# Development Review Comments

STP2024-00490

1<sup>st</sup> Submission Review Comments

622 Hungerford Drive – Washington Square

PROJECT NUMBER	----
DATE	2024.04.26
SCALE	1" = 20'
DRAWING TITLE	Garbage Truck Movement
DRAWING NUMBER	<b>EXB-04</b>

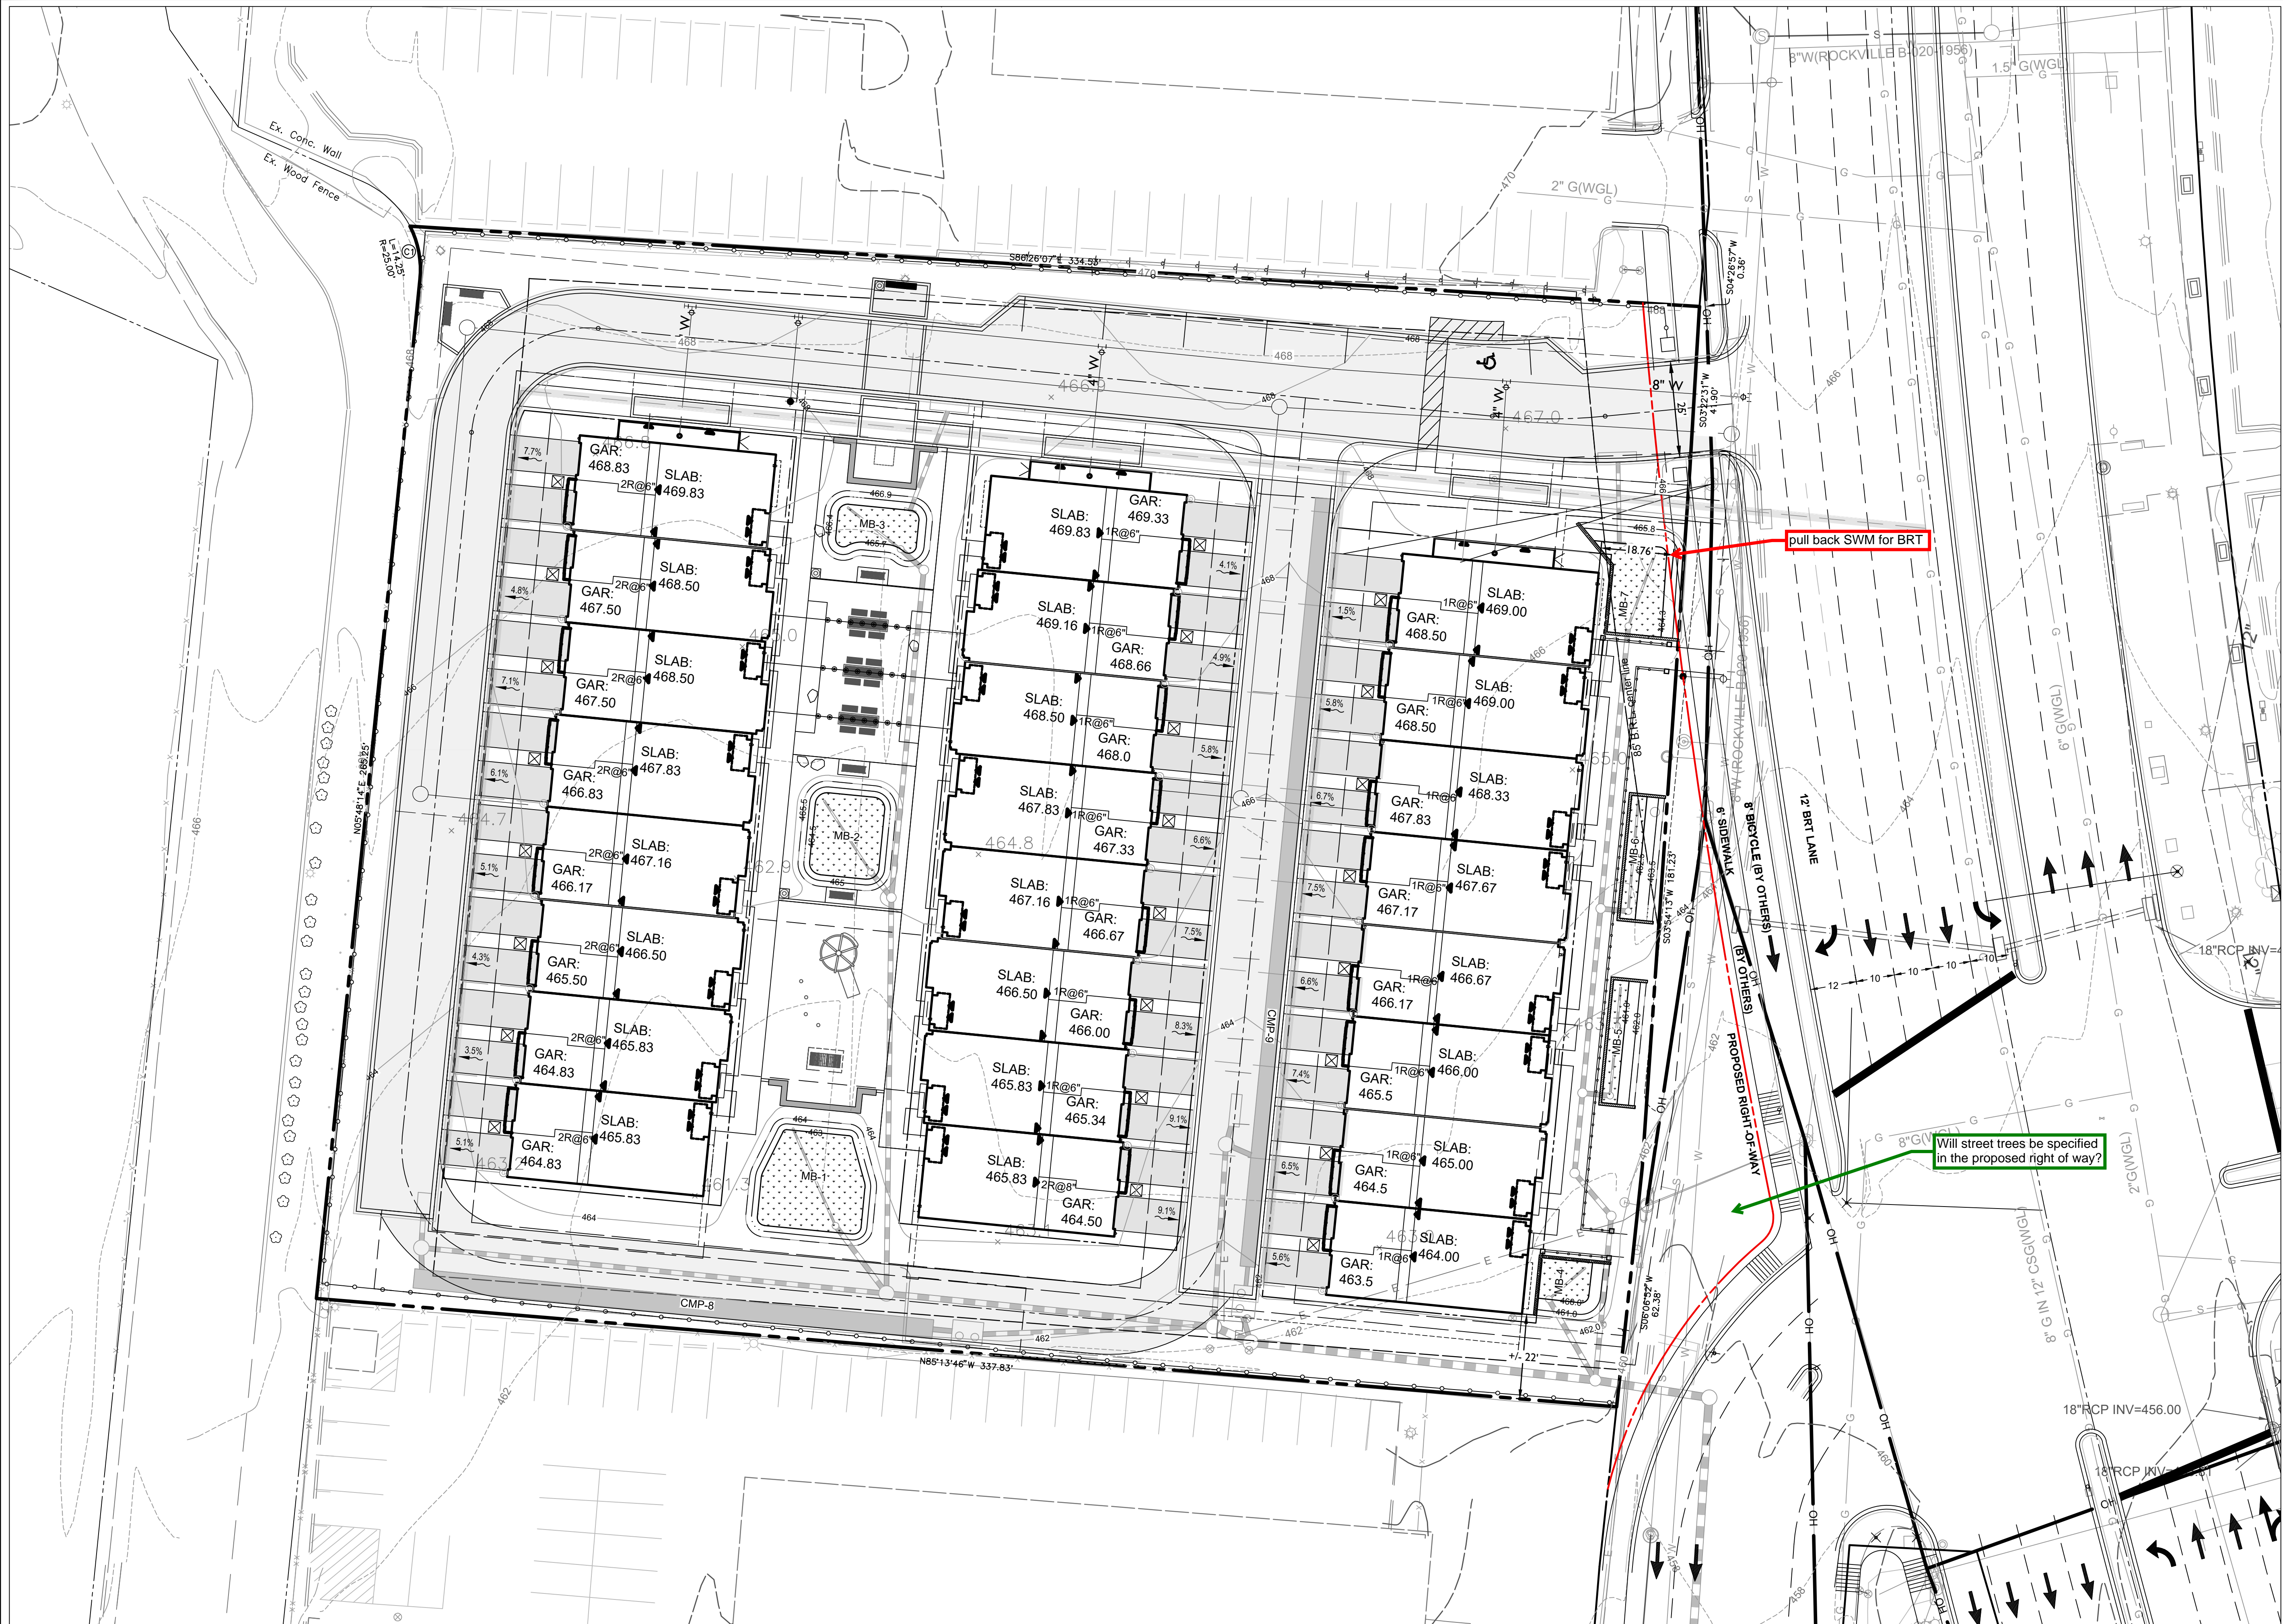
provide roadway cross sections of MD355 frontage  
under interim and ultimate conditions
